Union of Concerned Scientists

SUBJECT: SUPPLEMENT TO PETITION PURSUANT TO §2.206 – PROTECTION AGAINST CONTROL ROD DRIVE MECHANISM (CRDM) NOZZLE LEAKAGE FAST CORROSION SCENARIO OR MORE FIRSTENERGY FALSEHOODS

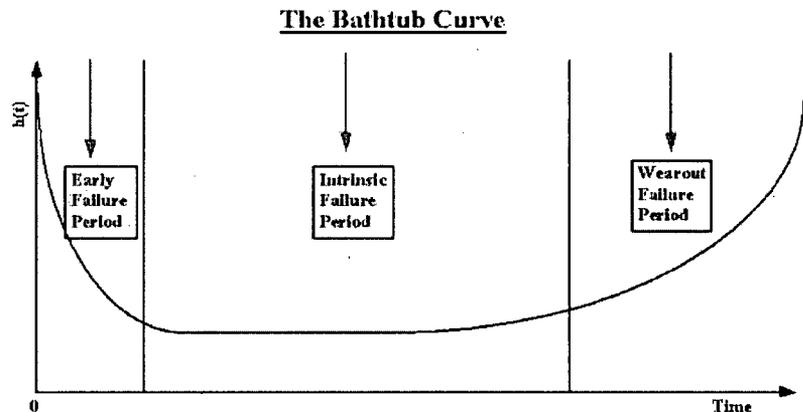
Many licensees have opted to replace the reactor vessel heads at their facilities. While such replacements reset the clock with regard to the NRC-mandated CRDM nozzle inspection frequency and scope, they do not prevent failure modes other than PWSCC. As you likely recall, failure rate versus time is illustrated in what is called the bathtub curve due to its shape.

The NRC-mandated inspections of CRDM nozzles are intended to manage the risk from the right side of the bathtub curve, the wear-out region. But replacement of reactor vessel heads and associated CRDM nozzles invokes the left side of the bathtub curve, the early failure region.

Failures in this region are not dominated by PWSCC but by failure mechanisms stemming from material defects, manufacturing errors, installation problems, and the like.
